Roundabout Traffic & Safety Assessment and Functional Design Review

Airport Road Environmental Assessment, King Street to
Huntsmill Drive

Prepared for Region of Peel
by IBI Group
August 9, 2019

A *Roundabout Functional Design Review – 1st Review draft* was completed on September 18, 2018 by John Bayley, P.Eng and Mr. Sergei Filippov, C.E.T. The design review provided observations, suggestions and comments on the functional aspects of each of the three roundabouts with inputs later incorporated into the designs, dated October 12 (refer to Exhibit 3-3, Exhibit 4-3, and Exhibit 5-3). Following the first review, *Roundabout Functional Design*

Exhibit 3-3: Roundabout Concept Drawing (October 12th) for Castlederg Side Road / Boston Mills Road

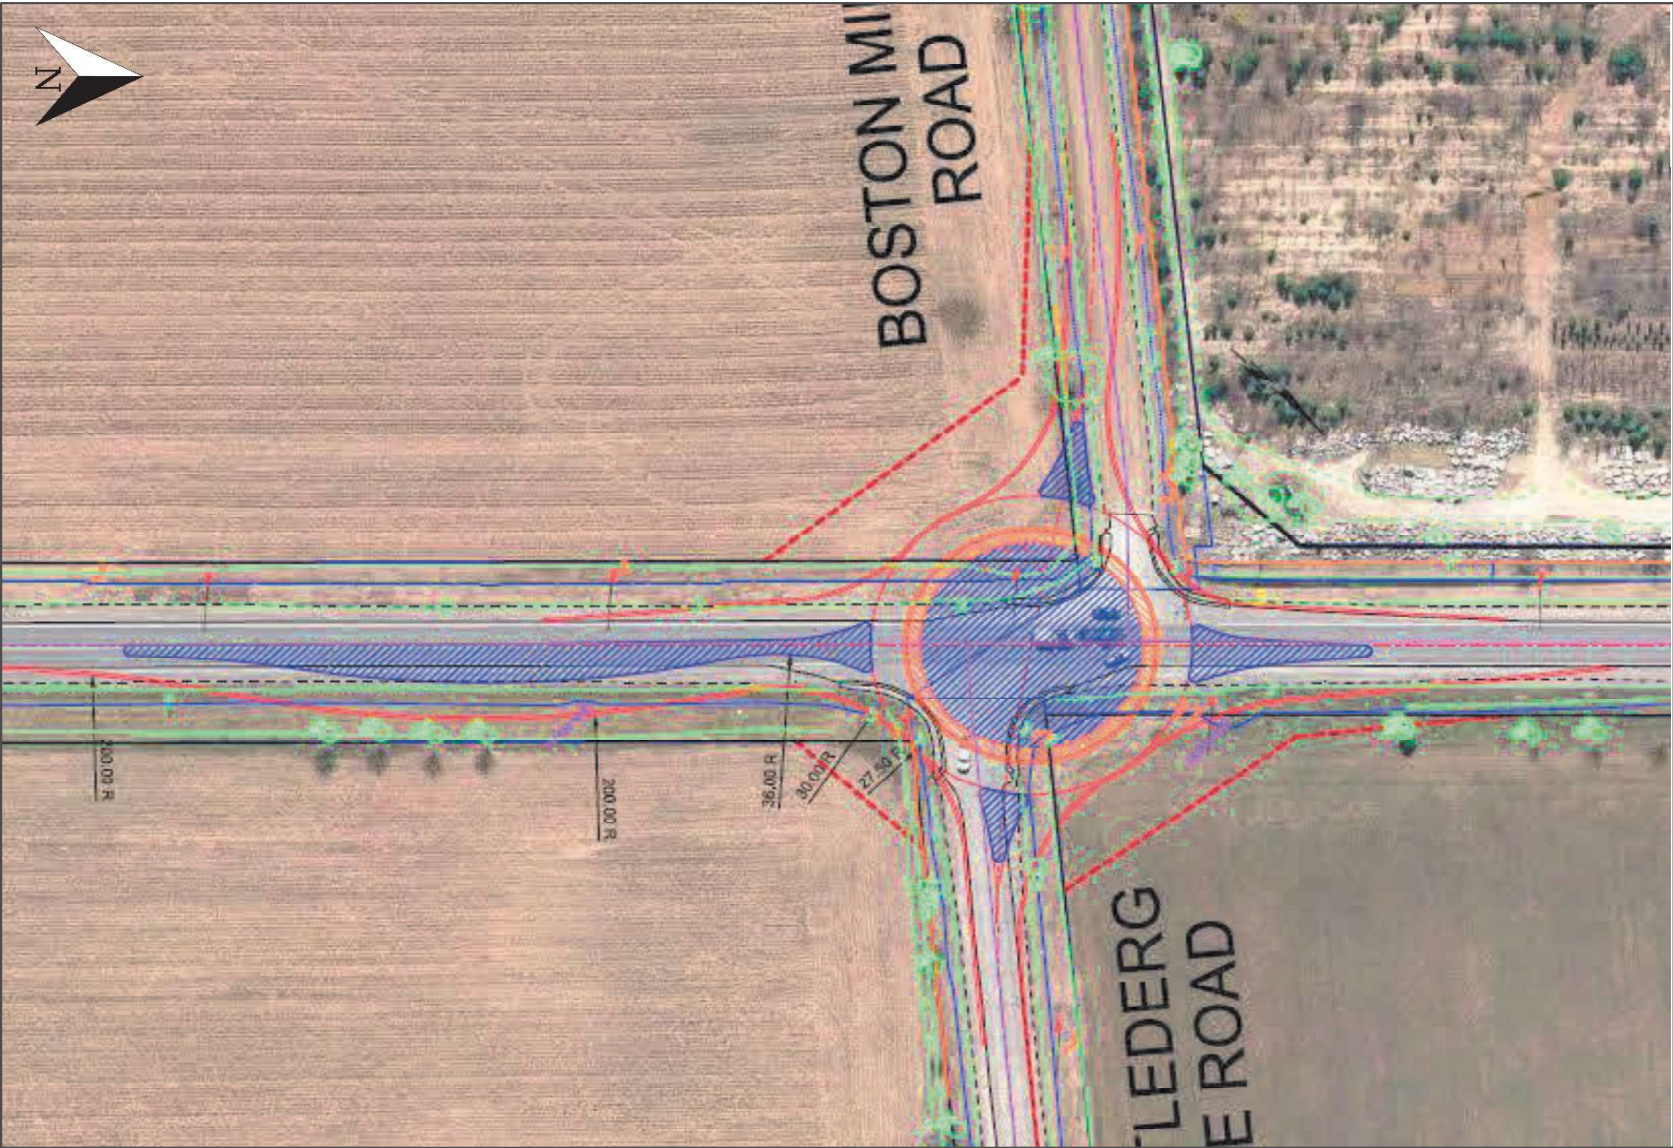
For the roundabout at Airport Road and Castleberg Side Road / Boston Mills Road, the design review details observations, suggestions and comments on the required geometric design inputs. This includes lane requirements, inscribed circle diameters (ICD), lane width minimums, active transportation provisions, as well as swept path and fastest path analyses. The review makes several recommendations for incorporation into design, which include prioritizing the safe movement of goods through further analyses of truck turning paths and fastest paths, developing a plan that minimizes impacts to the surrounding community when future widening is desired, as well as designing the approach geometry of roads to ensure safe operation of the roundabout with widening considerations.

- Shift roundabout centerline by 3.8 m north;
- Reduce back approach curb radius from 250 m to 200 m – entry path radius is kept at 30 m;
- Revise property requirements based on a two-lane roundabout size; and
- Adjust westbound approach.

Exhibit 4-3: Roundabout Concept Drawing (October 12th) for Olde Base Line Road

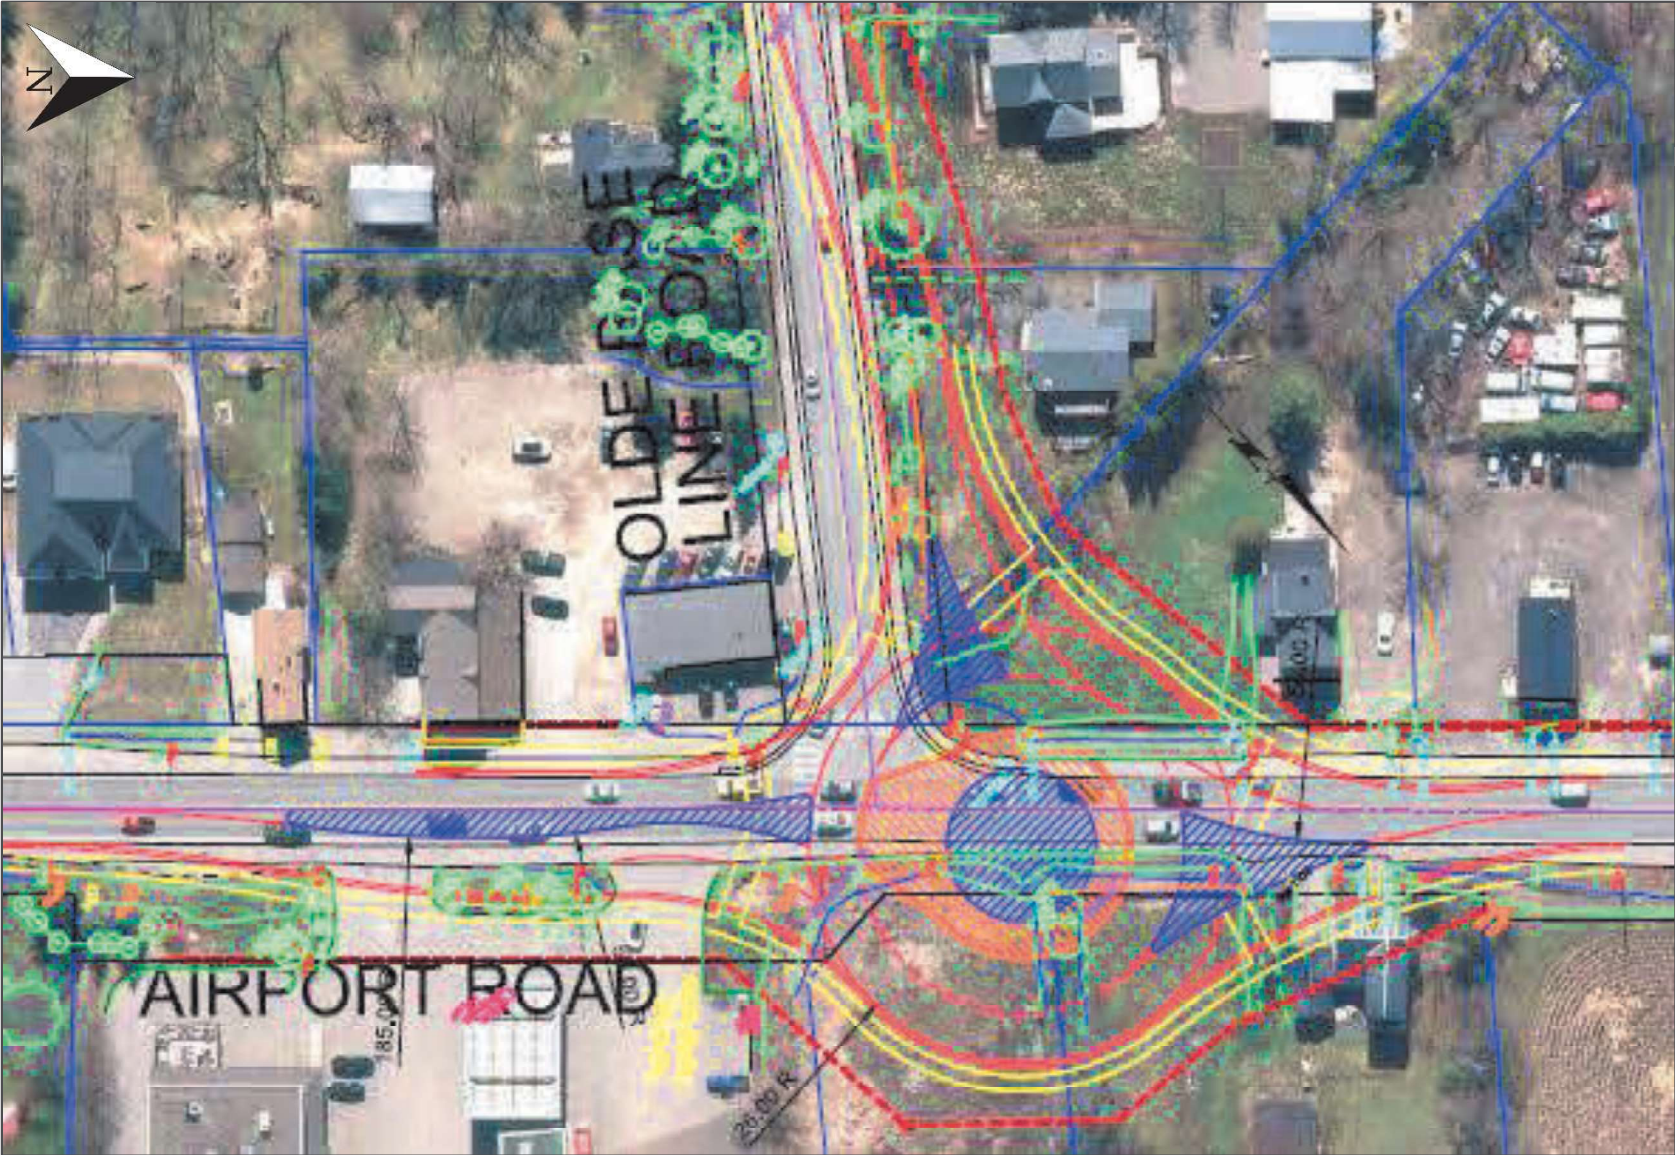
For the roundabout at Airport Road and Olde Base Line Road, the design review details observations, suggestions and comments on the required geometric design inputs. This includes lane requirements, inscribed circle diameters (ICD), lane width minimums, active transportation provisions, as well as swept path and fastest path analyses. The review makes several recommendations for incorporation into design, which include prioritizing the safe movement of goods through further analyses of truck turning paths and fastest paths, developing a plan that minimizes impacts to the surrounding community when future widening is desired, as well as designing the approach geometry of roads to ensure safe operation of the roundabout with widening considerations.

- Shift roundabout centerline by 10 m north;
- Adjust the eastbound connection to the roundabout while maintaining truck turning movement; and
- Revise proposed property line.

Exhibit 5-3: Roundabout Concept Drawing (October 12th) for Cranston Drive

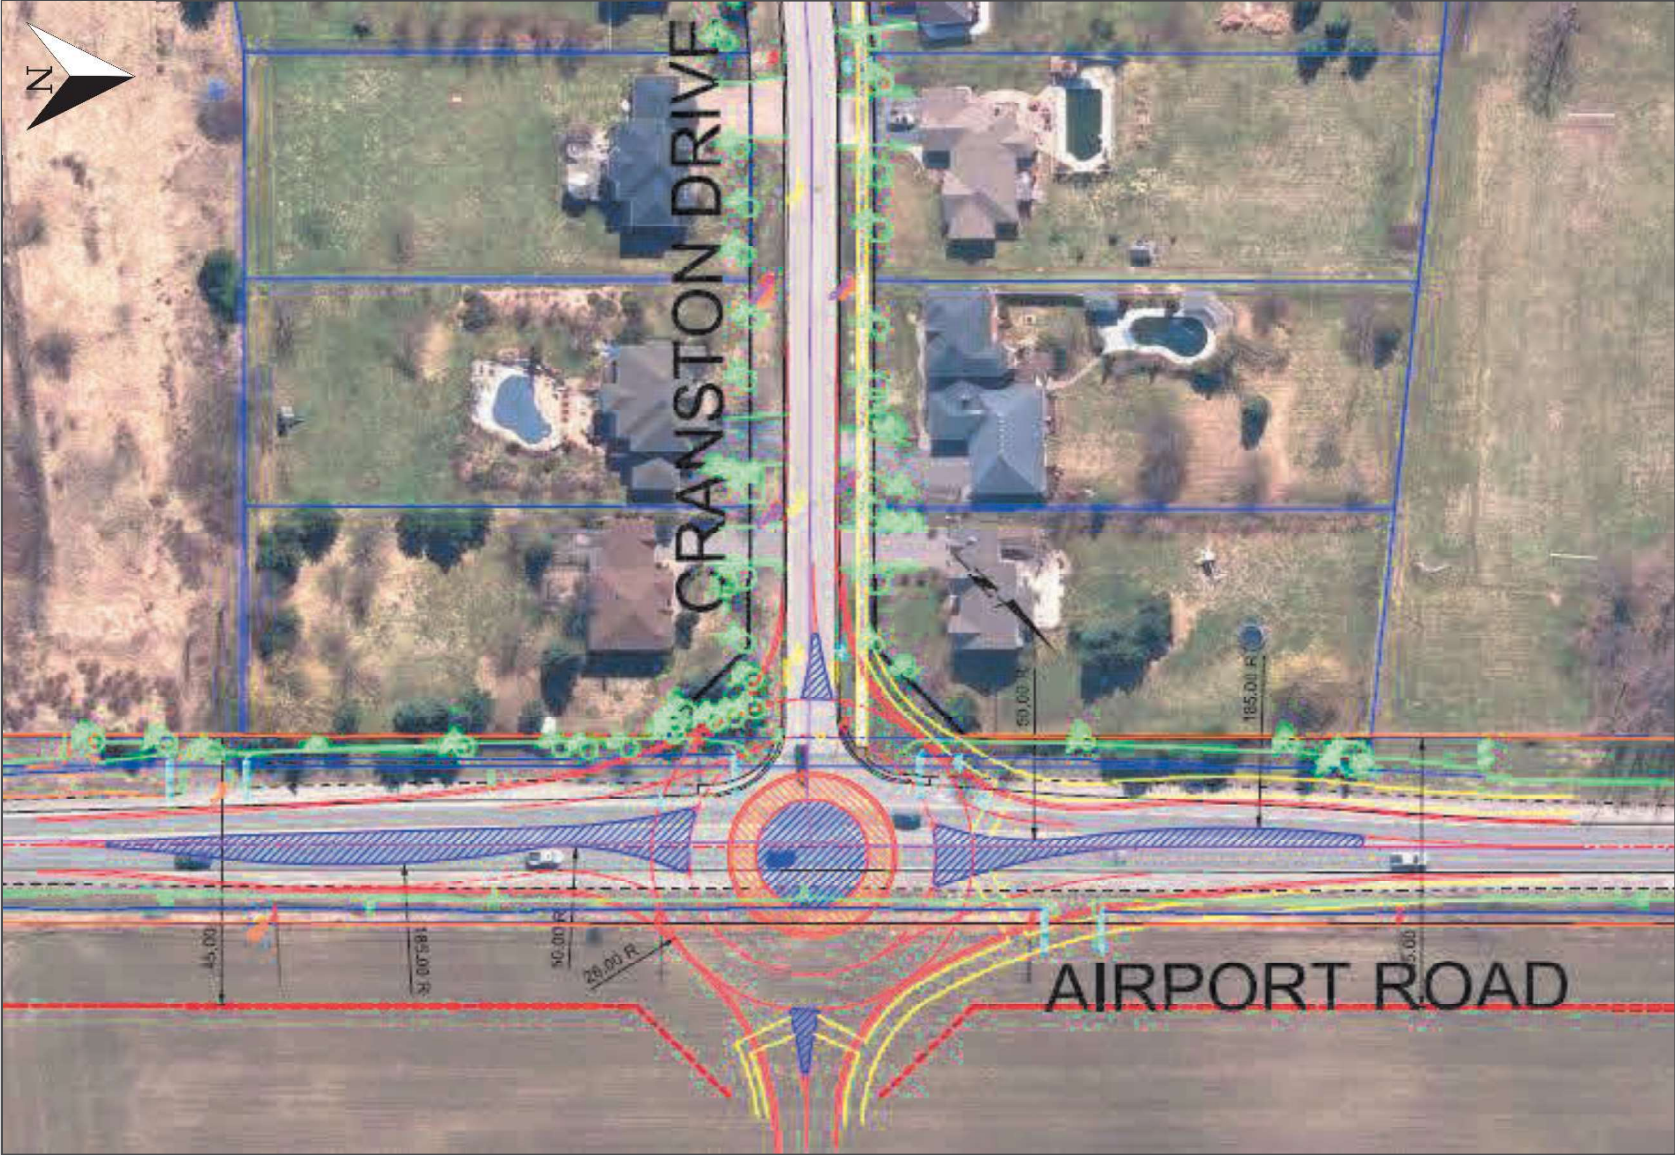
For the roundabout at Airport Road and Cranston Drive, the design review details observations, suggestions and comments on the required geometric design inputs. This includes lane requirements, inscribed circle diameters (ICD), lane width minimums, active transportation provisions, as well as swept path and fastest path analyses. The review makes several recommendations for incorporation into design, which include prioritizing the safe movement of goods through further analyses of truck turning paths and fastest paths, developing a plan that minimizes impacts to the surrounding community when future widening is desired, as well as designing the approach geometry of roads to ensure safe operation of the roundabout with widening considerations.

- Inscribed Circle Diameter (ICD) to 52m for multi-lane roundabout;
- Current design layout SB fastest path speeds approximately 49-40-68 km/h (R₁, R₂, and R₃) while NB fastest path speeds are approximately 51-37-109 km/h and a worst case maximum entry speed of 38 km/h on right turn movements. The higher than desirable exit velocity for the NB fastest path (109 km/h) should be refined to lower the speed in the area of the pedestrian crossing and as such have included an example modification (refer to Appendix E) that will achieve lower exit velocity (69 km/h) at the departure for the NB through movement (NE quadrant). Similar considerations should be given to the SB movement and further refined for NB movement using both lane narrowing and possible ICD reduction combined with modified deflection of the departure geometries to further reduce exit velocities.

FIGURE 2

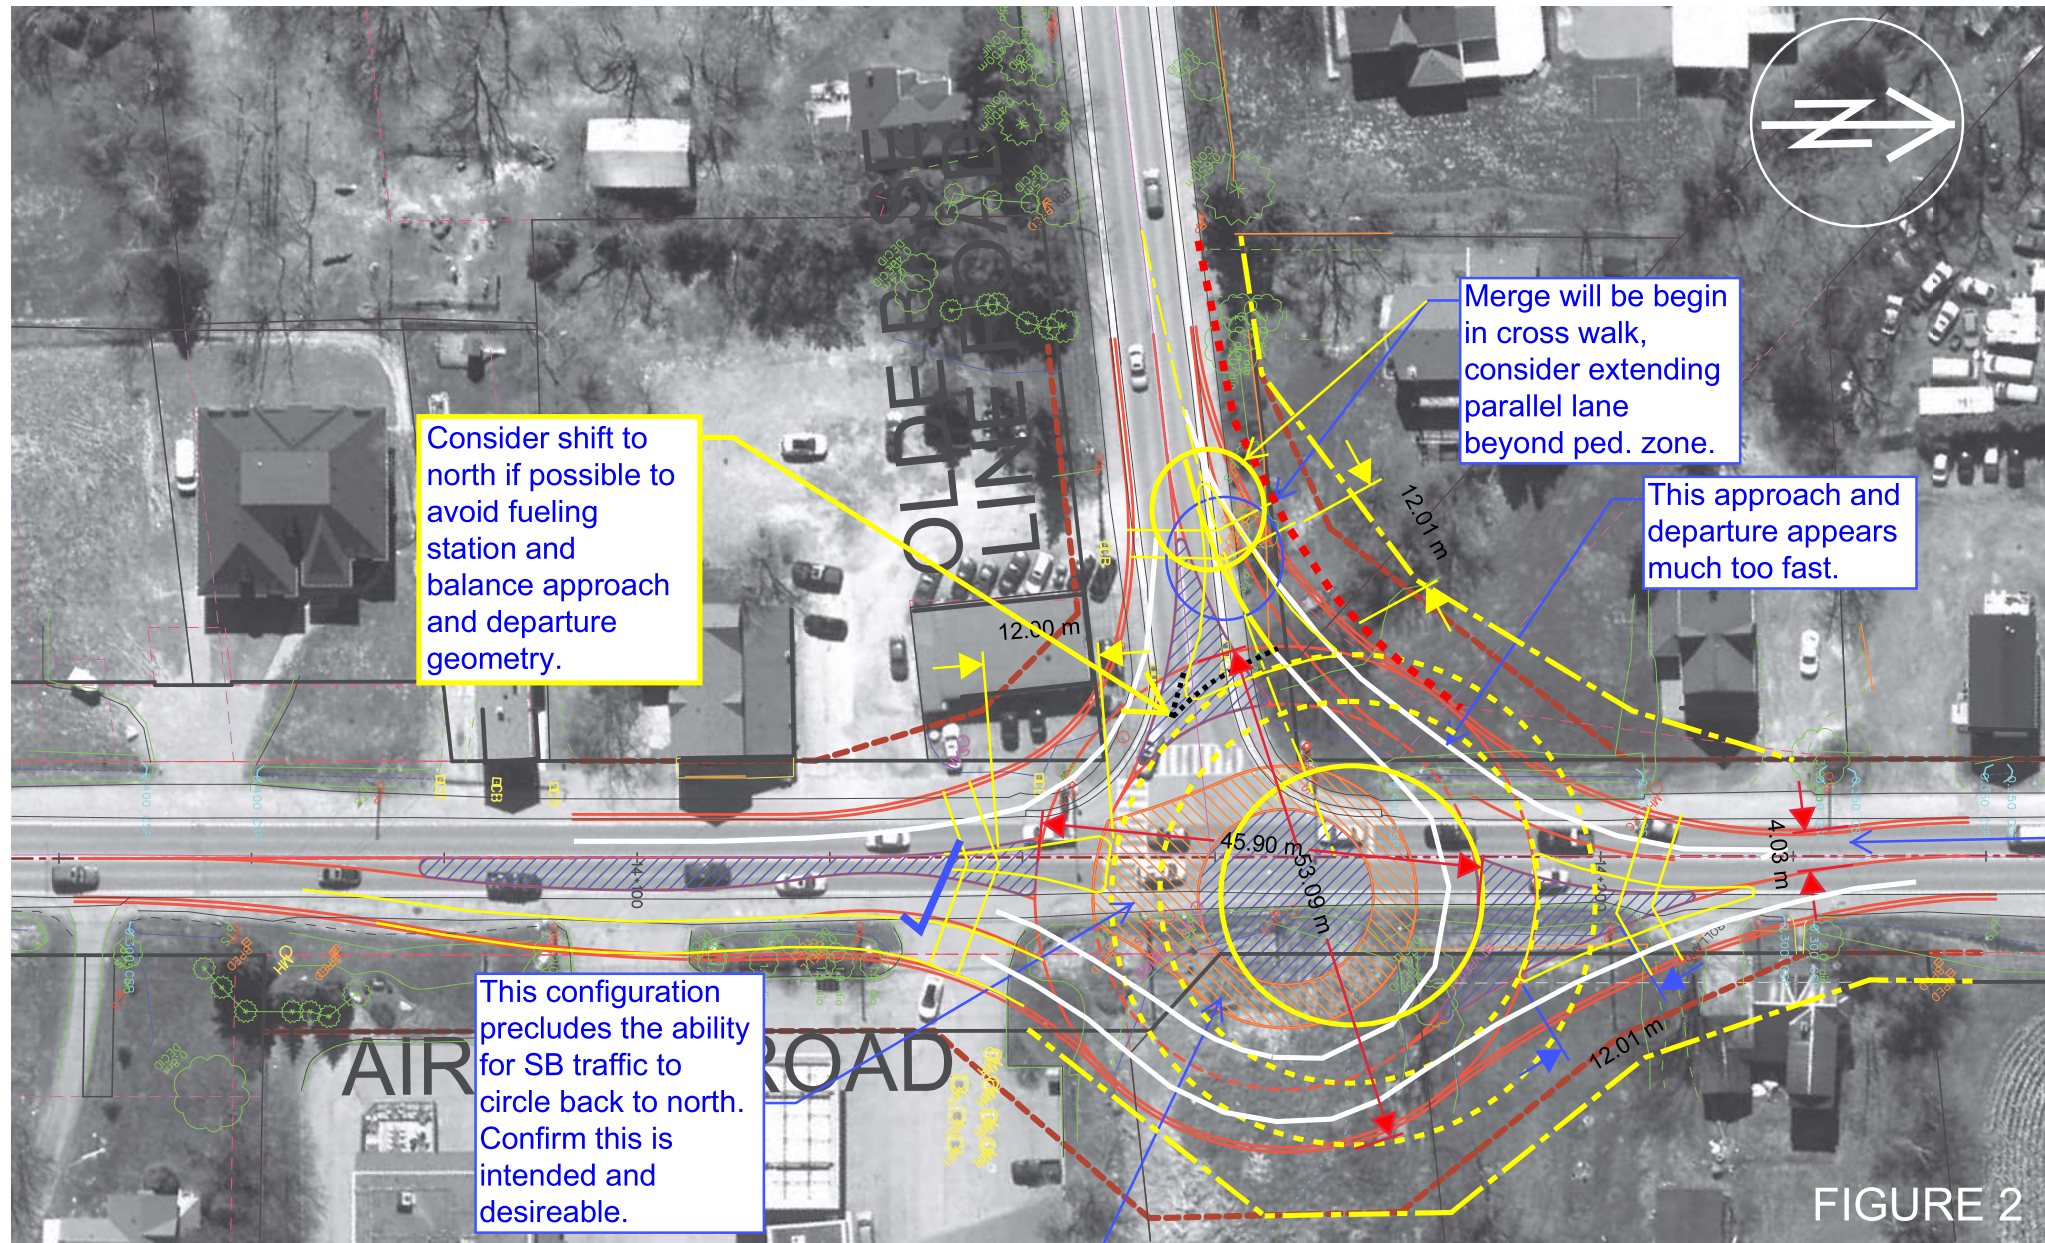
Refer to markup Figure 2 for specifics of review.

Truck Turning – See Swept Path analyses in Figure 2A. West leg appears to be too narrow to accommodate WB-20 truck movements.

Compatibility and Access – Access points within the approach and departure zones is not favoured but may be required nonetheless. For this roundabout the access points will include existing commercial sites and petroleum filling station entrances, Future planning and development should consider access relocations outside the weaving areas associated with the entries and departures.

Daylighting and Sight Lines – refer to Figure 2. Typical daylight areas are illustrated on the plans and will be subject to a detailed review at the 30% design stage and beyond. Property acquisition, environmental concerns and required design elements and vertical obstructions, including signs, utility poles, controller cabinets, trees, fences and buildings, etc. should be reviewed in further detail from a three dimensional perspective prior to finalizing the preferred roundabout siting.
